ZONE CHANGE REVIEW SHEET

CASE: C814-88-0001.10
Canyons @ Rob Roy Rezoning

ADDRESS: 800 N. Capitol of Texas Highway

Staff recommends Planned Unit Development (PUD) zoning with the following changes to Exhibit “H” of the PUD Land Use Plan -

LAND USE SUMMARY - DAVENPORT WEST P.U.D.

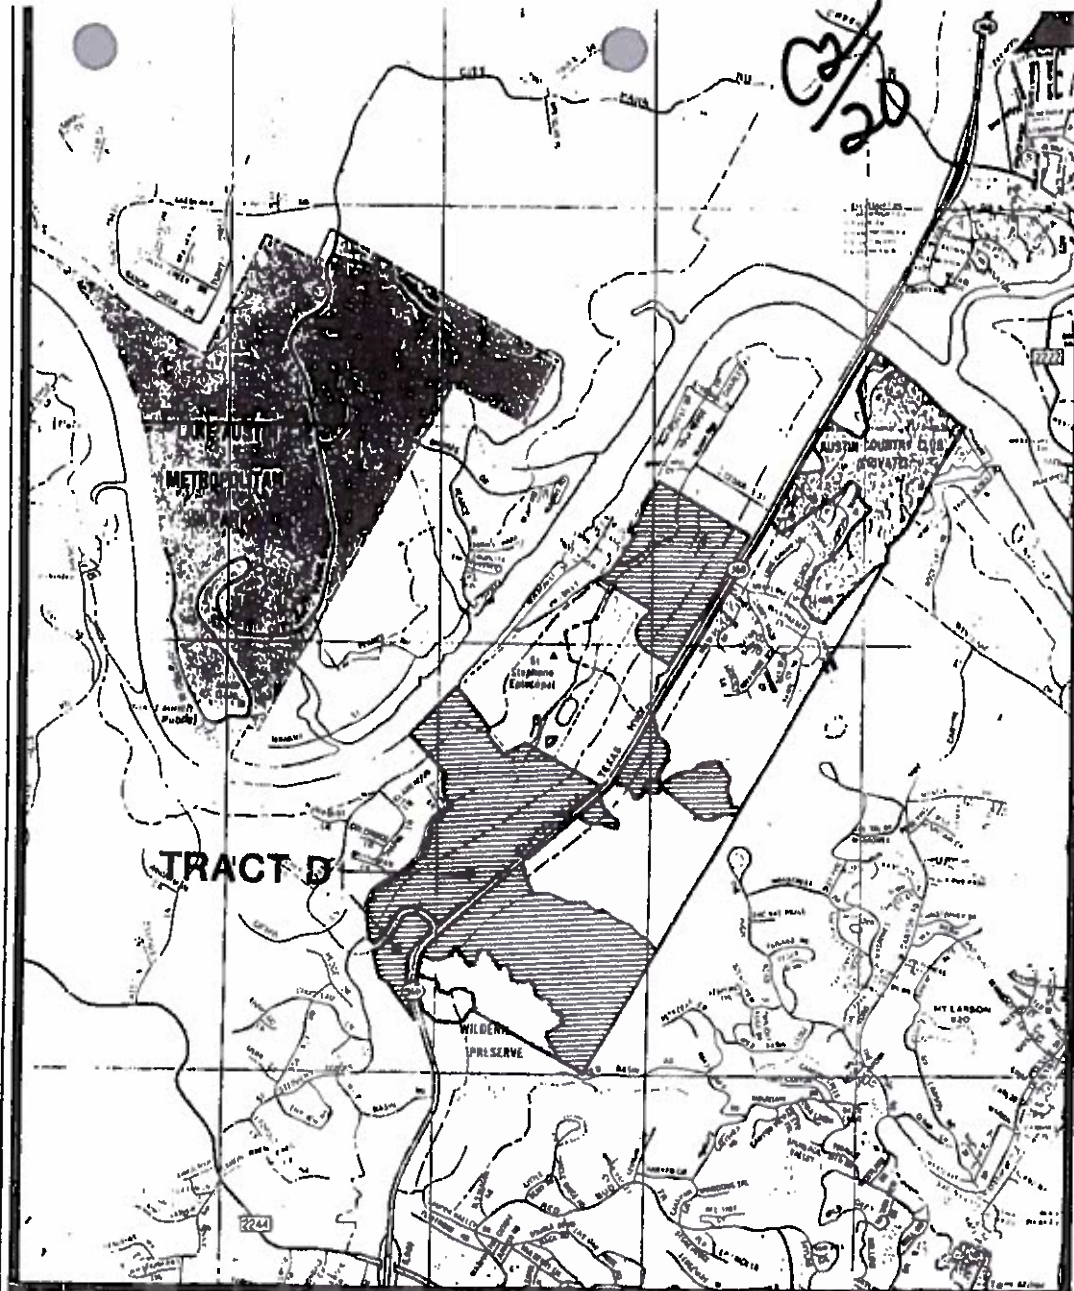
Exhibit "H" Land Use Plan. Change the Overall Summary by General Land Use Table on Sheet 1 to reflect a change from office use to multifamily use; adjust the acreages accordingly.

Exhibit "H" Land Use Plan. Change the Land Use Summary Table on Sheet 1 to reflect the correct lot and change the proposed land use from office to multifamily.

Justification. The Property was zoned for office use in 1988, since then it has remained undeveloped. West Austin lacks a sufficient supply of multifamily development for families looking to move to the area that otherwise might not be able to afford owning their own home. The few multifamily developments located in the surrounding area experience an occupancy rate of over 90%. Additionally, the proposed low density multifamily residential use provides a better transition between Capital Texas Highway located to the west and the residential uses located to the north and east of the site.

Justification. The Property was zoned for office use in 1988, since then it has remained undeveloped. West Austin lacks a sufficient supply of multifamily development for families looking to move to the area that otherwise might not be able to afford owning their own home. The few multifamily developments located in the surrounding area experience an occupancy rate of over 90%. Additionally, the proposed low density multifamily residential use provides a better transition between Capital Texas Highway located to the west and the residential uses located to the north and east of the site.

C2/2

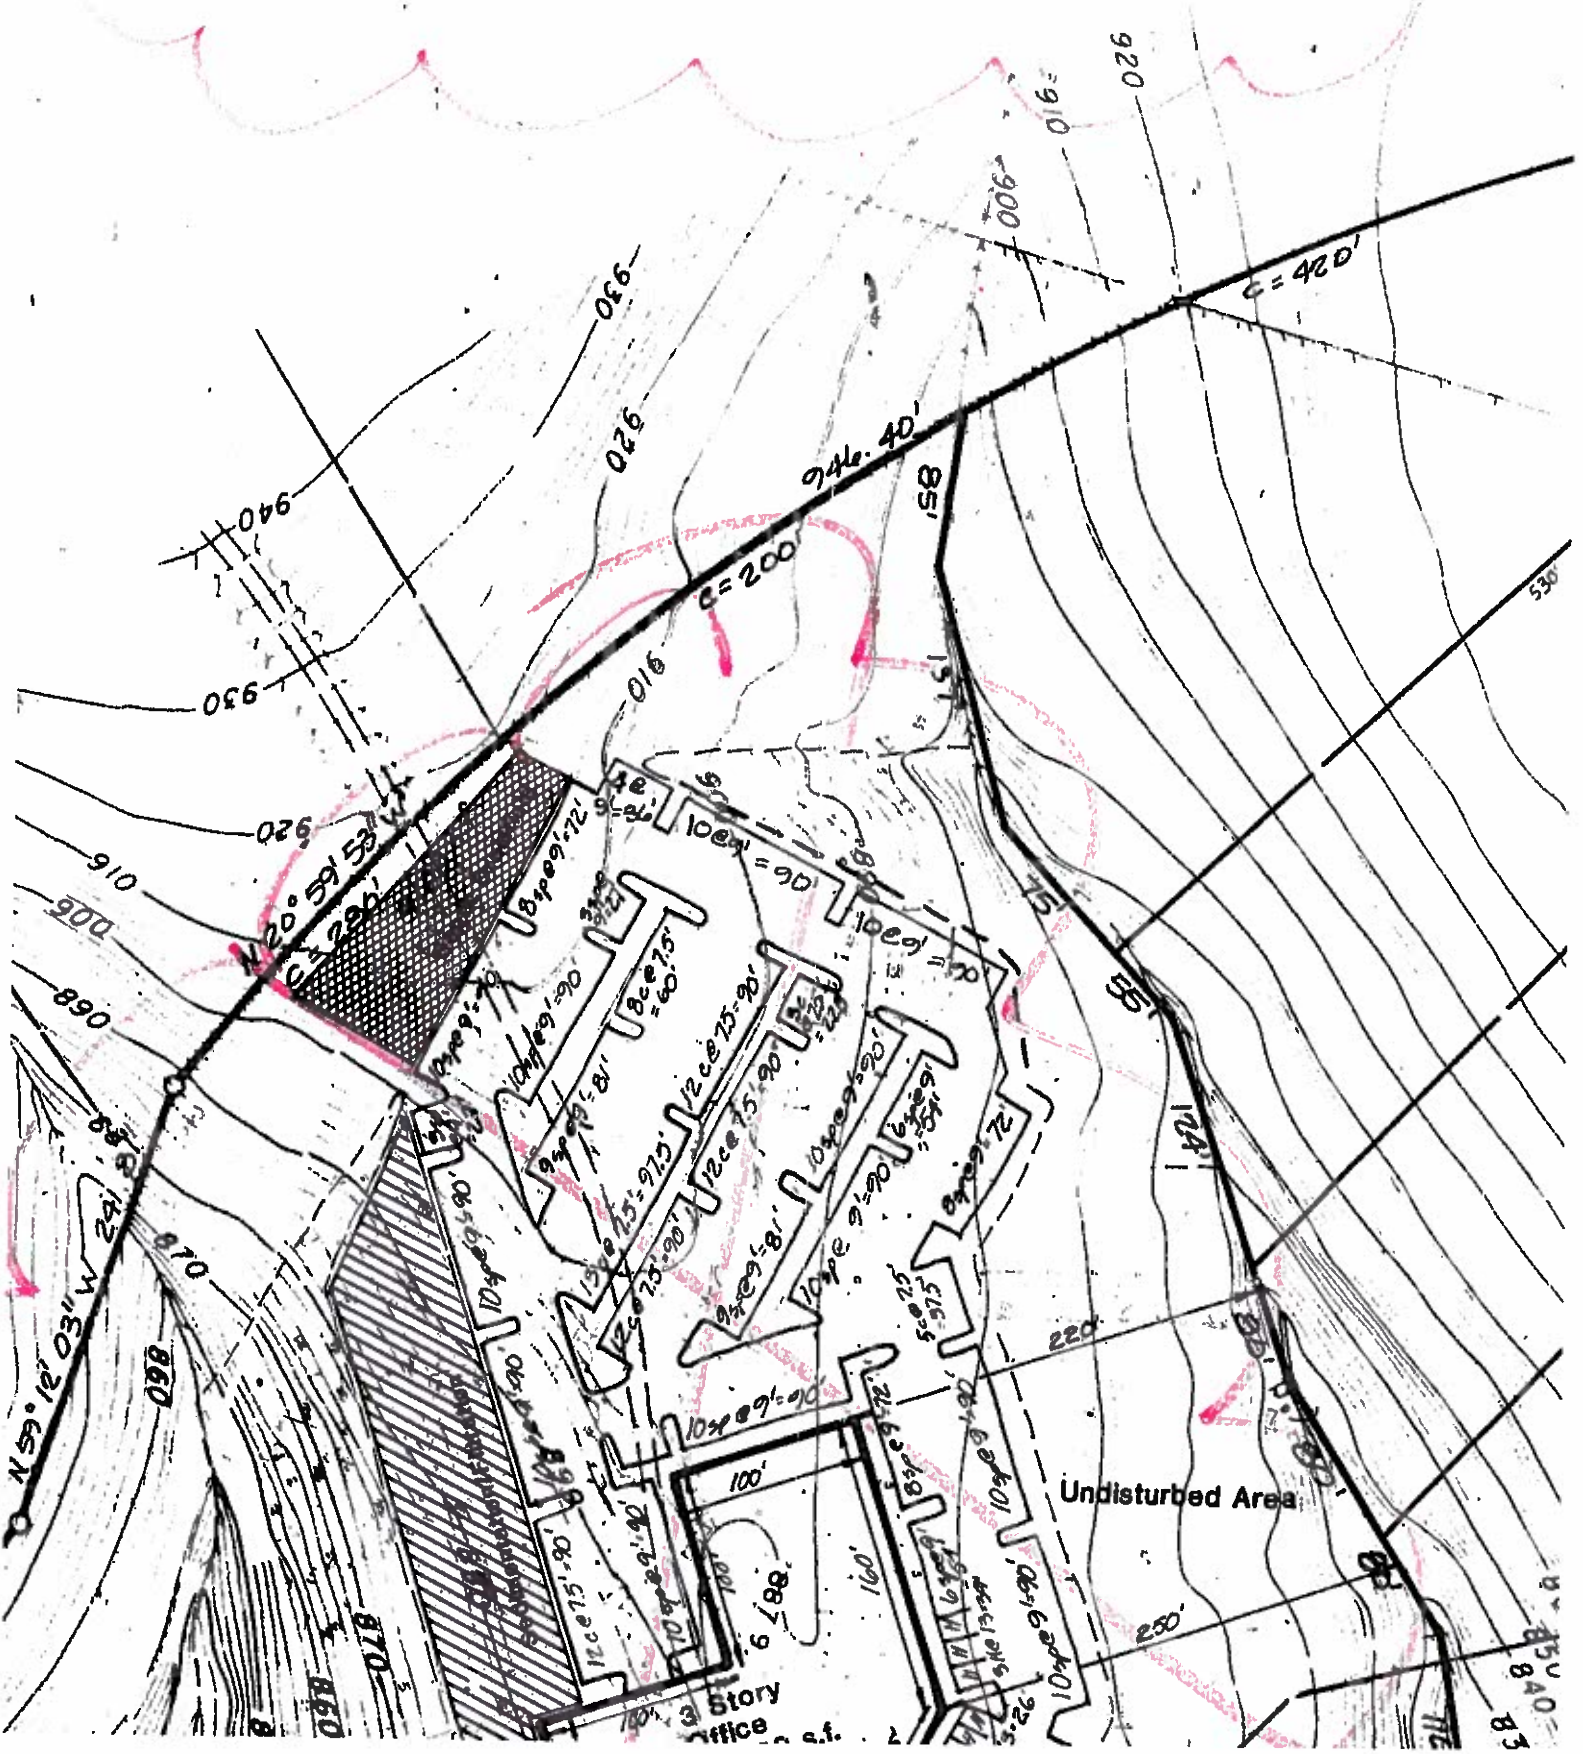
Exhibit "H" Land Use Plan. Clarify Ordinance Compliance Note #1 on Sheet 2 to read "*Single family*" residential areas are limited to a density of one unit per two acres of gross site area, with minimum one acre lots."

Exhibit "H" Land Use Plan. Change the Hill County Roadway Ordinance Calculations on Sheet 2 to deduct the site area calculations of Lot A-1.

Exhibit "H" Land Use Plan. Change the F.A.R. & Parking Summary Table on Sheet 2 to reflect Lot A-1 as a multifamily project.

Exhibit "H" Land Use Plan. Change the diagram on Sheet 2 for Lot A-1 from "LO" to "MF-2".

Justification. As supported by Section 1.04 of the Restrictive Covenant recorded in Volume 10909, Page 1601 of the Real Property Records of Travis County, Texas for the Davenport Ranch West Planned Unit Development Section One, this restriction was intended to apply solely to single family residential development. I have attached a copy of the Restrictive Covenant for your reference with the companion Restrictive Covenant Amendment case.

Justification. Per the Hill County Roadway Ordinance the floor to area limitations only apply to nonresidential buildings.

Justification. The parking table only provides parking calculations associated with the office development on Tract D. Since the use is changing from office to multifamily we have updated the table accordingly.

Justification. The Property was zoned for office use in 1988, since then it has remained undeveloped. West Austin lacks a sufficient supply of multifamily development for families looking to move to the area that otherwise might not be able to afford owning their own home. The few multifamily developments located in the surrounding area experience an occupancy rate of over 90%. Additionally, the proposed low density multifamily residential use provides a better transition between Capital Texas Highway located to the west and the residential uses located to the north and east of the site.

ORDINANCE CALCULATION SUMMARY

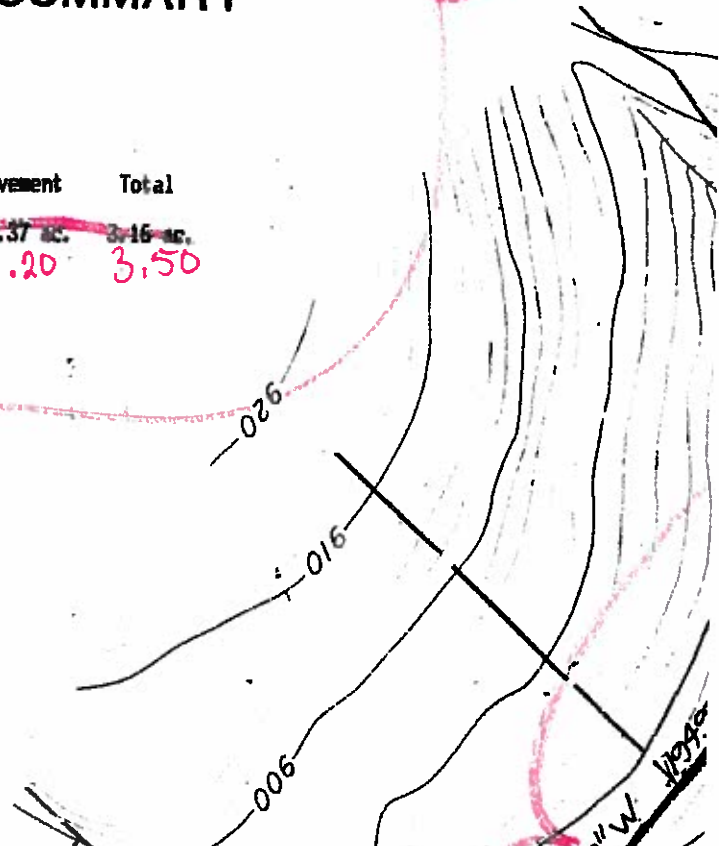
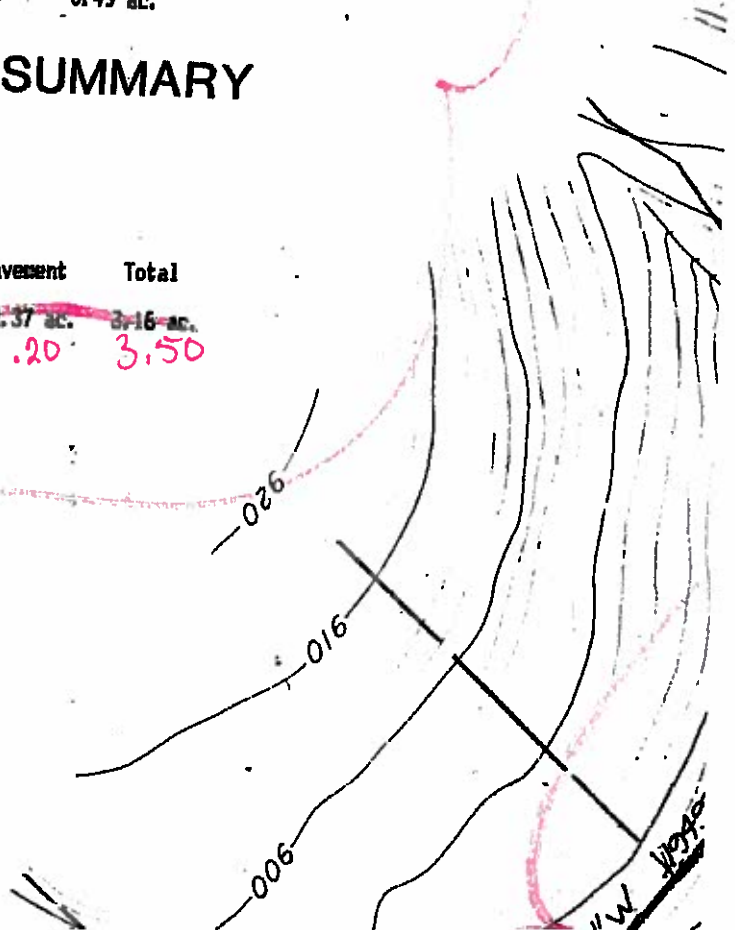
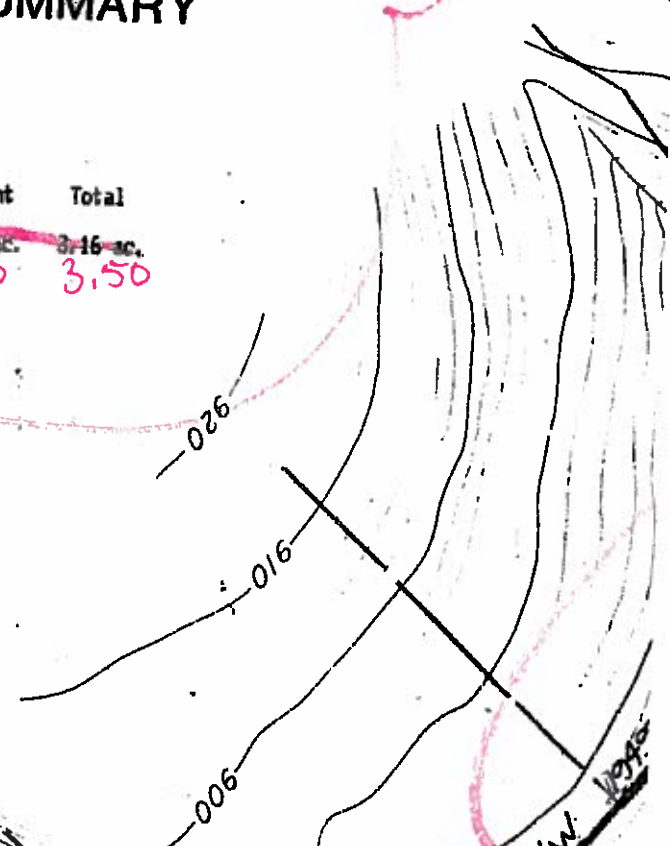
Exhibit "H" Land Use Plan. Remove the floor to area multiplier calculations and the allowable square footage calculations on Sheet 3.

Exhibit "H" Land Use Plan. Change the proposed impervious cover from 3.16 acres to 3.50 acres.

Exhibit "H" Land Use Plan. Change the Impervious Cover Summary Table on Sheet 3 to reflect the proposed impervious cover and to account for a different building configuration and parking layout.

Exhibit "H" Land Use Plan. Change the Comprehensive Watershed Ordinance Table on Sheet 3 to reflect the proposed impervious cover.

Justification. Per the Hill County Roadway Ordinance the floor to area limitations only apply to nonresidential buildings.

Justification. While the proposed impervious cover is slightly more than the previous office project, this project is still under the 3.52 acres of impervious cover allowed for Lot A-1.

Justification. While the proposed impervious cover is slightly more than the previous office project, this project is still under the 3.52 acres of impervious cover allowed for Lot A-1. The prior office project proposed a vast amount of surface parking with a small building footprint. Since the use of the site is changing from office to multifamily the size and configuration of the building and parking area must also change to accommodate a more user friendly development. The proposal is to provide a wrapped product type with structured parking within.

Justification. While the proposed impervious cover is slightly more than the previous office project, this project is still under the 3.52 acres of impervious cover allowed for Lot A-1.

ORDINANCE CALCULATIONS

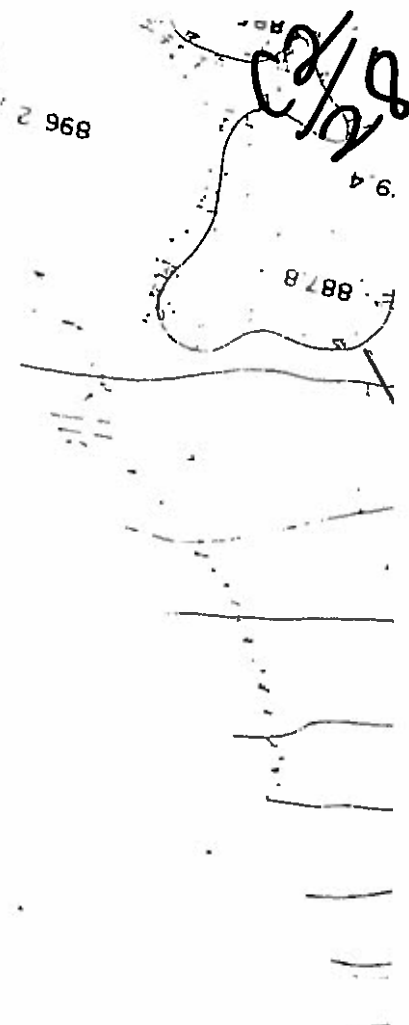
Exhibit "H". Land Use Plan. Remove the Hill County Roadway Ordinance Table on Sheet 3.

Justification. Per the Hill County Roadway Ordinance the floor to area limitations only apply to nonresidential buildings.
